November 10, 2026
7:00 PM
Planning Board Agenda

Continue public hearing and continue review of application for Amended Site Plan Approval, 364 Main Street, Mixed-Use Commercial and Residential, submitted by 364 Main BCN LLC.

Re: 364 Main BCN LLC – Supplemental Submission
Application for Site Plan Amendments Involving Field Changes
Property: 364 Main Street, Beacon, New York 12508 (ID: 6054-29-006819)

RESPONSE LETTER

3 ENLARGED LANDSCAPE PLAN
1/8" = 1'-0"

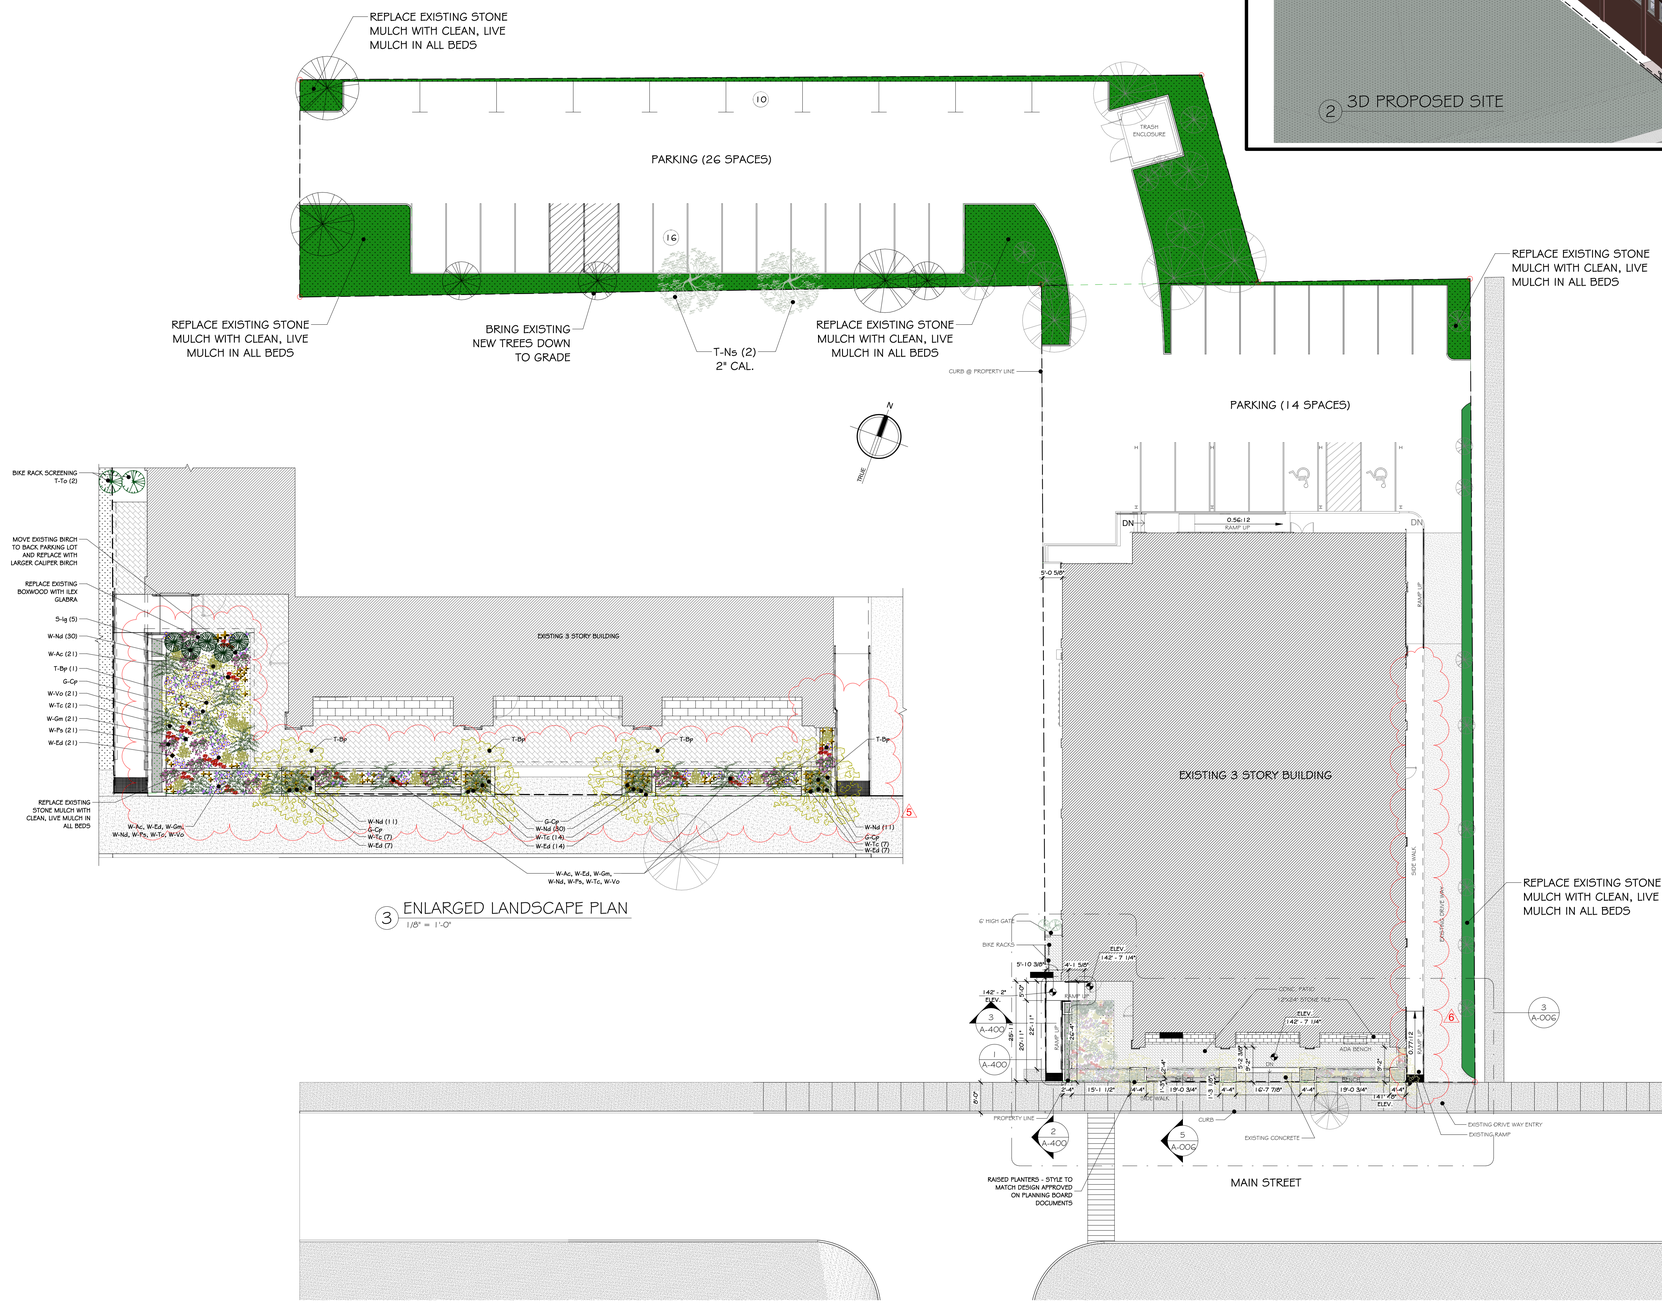
Comment No.	Topic	Page No. / Section No.	Reviewer Comment	Respondent	Response
2	Landscape	Landscape Plan	The submitted landscape plan shall be updated to reflect who prepared the plan.	Landscape Restorations / ADG	This has been addressed. The review letter addressed the Landscape Plan Revision dated August 21, 2026. The revised Landscape Plan dated September 8, 2026, submitted with the applicant's letter of September 30, 2026, identifies the preparer, Landscape Restorations of Beacon, New York, in its title block.
3	Landscape	Landscape Plan; A-006	The landscape plan shall include an enlarged view for the landscaping proposed along the front of the building, so that it is clearly detailed and legible.	Landscape Restorations / ADG	This has been addressed. The September 8, 2026 Landscape Plan includes an Enlarged Landscape Plan (Detail 2) of the planting along the Main Street frontage, with each species and quantity labeled. The same enlarged plan and plant list are shown on Sheet A-006 (Detail 3).

4	Landscape	Landscape Plan; A-006	The landscape plan reflect three (3) trees (Thuja) to be planted to the west side of the building to screen the bike racks. It appears that 1 of the proposed trees is being planted on the neighbors parcel. Has the owner of the neighboring parcel agreed to the planting of a tree on their parcel? If so, a copy of the written agreement shall be provided to the Planning Board. If not, then the tree should be relocated so that all plantings occur on the subject parcel.	Landscape Restorations / ADG	This has been addressed. The September 8, 2026 Landscape Plan reduces the bike rack screening to two (2) Thuja occidentalis 'Emerald Green' (T-To), both located on the subject parcel beside the building at the bike racks. No planting is proposed on the neighboring parcel, and no agreement with the adjoining owner is required. See also Sheet A-006.
5	Architectural	A-006	The trees and callout for "plants in stone" on Sheet A-006 shall be revised to reflect the landscape plan submitted. The landscape plan reflects that the stone is being removed, and that there is a singular tree in the landscaped area in the front left	ADG	This has been addressed. Sheet A-006 has been revised to agree with the September 8, 2026 Landscape Plan. The "plants in stone" callout has been removed, the beds are noted to have the existing stone mulch replaced with clean, live mulch, and the front

Comment No.	Topic	Page No. / Section No.	Reviewer Comment	Respondent	Response
			corner.		left landscaped area shows the single white birch (T-Bp) shown on the landscape plan. The landscape plan's plant list and enlarged plan have also been added to the sheet.

1 TYP. WINDOW HEAD ELEVATION DETAIL
1/2" = 1'-0"

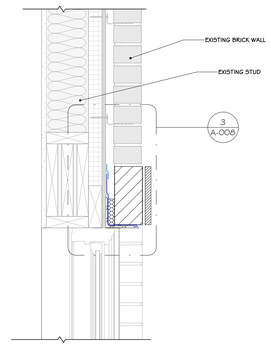
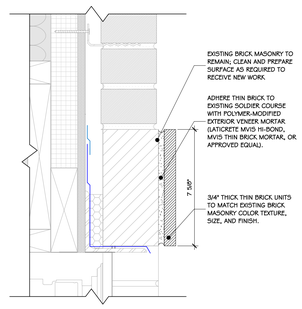
18	Window Head Detailing	PB renderings showed straight brick head; PB elevations showed arched heads. City-approved CDs called out an arched Azek profile.	A straight full-brick soldier course window head detail was installed.	The contractor opted for a straight soldier course brick head, feeling that it was compatible with the building's overall character and the full-brick masonry upgrade.	We propose to install painted PVC Fypon window headers toto align with the approved drawings. (Post ARB) The arched window head from the original design was determined to be working against the overall aesthetics of the façade. A straight thin brick soldier course header is proposed to add shadow and depth.
	19	Residential Entrance (Main Street)	A projected entrance canopy was specified.	The canopy was removed, and a recessed entryway was provided.	It was felt that the projected canopy was going to be a maintenance issue, and the recessed entryway would achieve the same technical solution, creating a permanent, integrated arrival point that protects residents from the weather	To address architectural detailing associated with a primary entrance point, we are now proposing to add the canopy and construct flanking pilasters to more closely align with the design and proportions of the original design. (Post ARB) Proportions and detailing of the canopy were revised per ARB comments. (Post ARB 2) Proportions and detailing were further revised to lighten and simplify the pilasters and canopy.
